## Committee of Experts on the Transport of Dangerous Goods and on the Globally Harmonized System of Classification and Labelling of Chemicals

Sub-Committee of Experts on the Transport of Dangerous Goods

## Hazard-based system for classification of lithium batteries

### Transmitted by the experts from Belgium and France and by the Advanced Rechargeable and Lithium Batteries Association (RECHARGE) on behalf of the informal working group

**Figure 38.3.6 : Classification criteria for lithium metal, lithium ion and sodium ion cells and batteries**

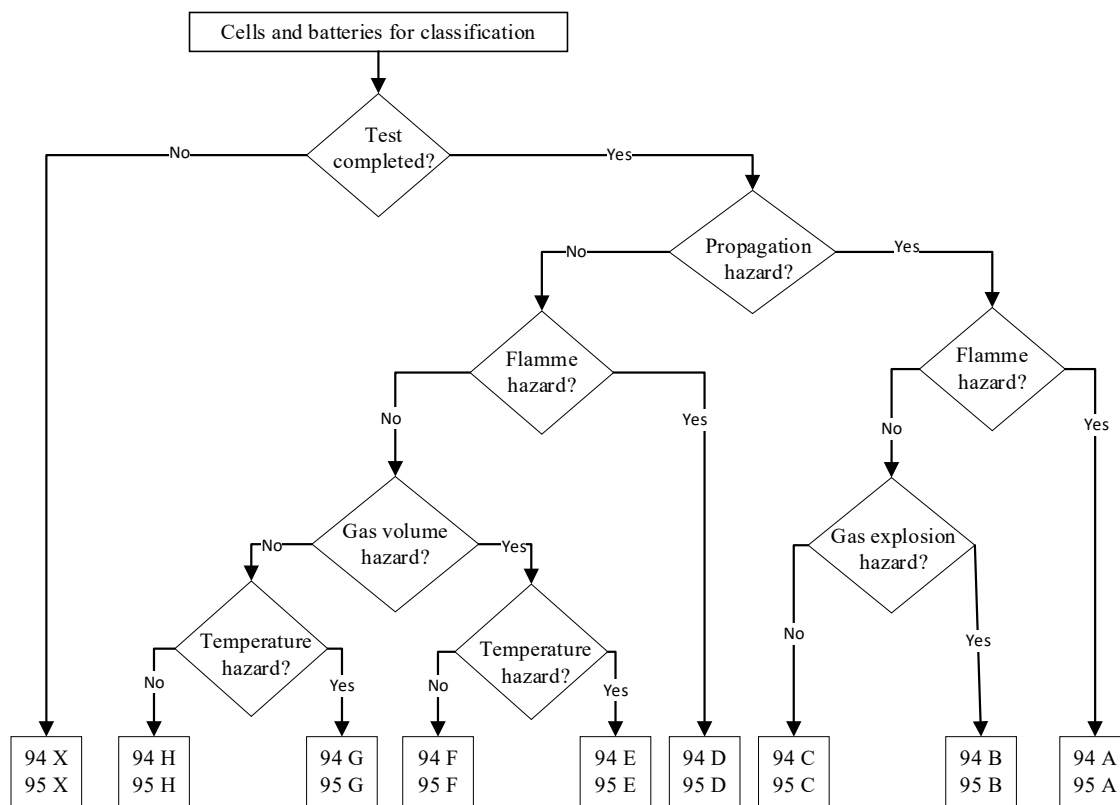
The divisions of 2.9.4.2. and 2.9.5.2. of the *Model Regulations* are defined according to the following flowchart. Cells and batteries are assigned to one of these divisions which corresponds to the results of the tests performed according to the following procedures.

The most severe hazard measured over the 3 valid tests shall be reported as the cell or battery test results.

***COMMENT:FOR THE CELLS OR BATTERIES THAT WOULD NOT INITIATE A THERMAL RUNAWAY AT A FULLY CHARGED STATE OF CHARGE WHEN APPLYING THE TEST PROTOCOLS, THE INFORMAL WORKING GROUP WILL LOOK AT APPROPRIATE TRANSPORT CONDITIONS:***

- THE CELL OR THE BATTERY MAY BE ASSIGNED TO THE RELEVANT CATEGORY ACCORDING TO THE TEST RESULT (DIVISIONS 94F TO 94H OR 95F TO 95H); OR
- ALTERNATIVELY, SUCH CELLS MAY BE ELIGIBLE FOR TRANSPORT UNDER CONDITIONS AUTHORIZED BY COMPETENT AUTHORITIES, UNTIL THE REGULATION IS AMENDED TO ADDRESS THESE NON-REACTIVE TECHNOLOGIES (E.G. SOLID STATE BATTERIES). THE COMPETENT AUTHORITY MAY DECIDE UPON THE TRANSPORT CONDITION BASED ON A COMPLEMENTARY DOSSIER INCLUDING: THE DEMONSTRATION OF THE ABSENCE OF REACTION DURING THE UN TEST (PARTICULARLY CELL SHORT CIRCUIT AND CRUSHING) [AND AN ARC TEST UNTIL 400°C DEMONSTRATING THE ABSENCE OF REACTION OF THE CHEMISTRY USED].
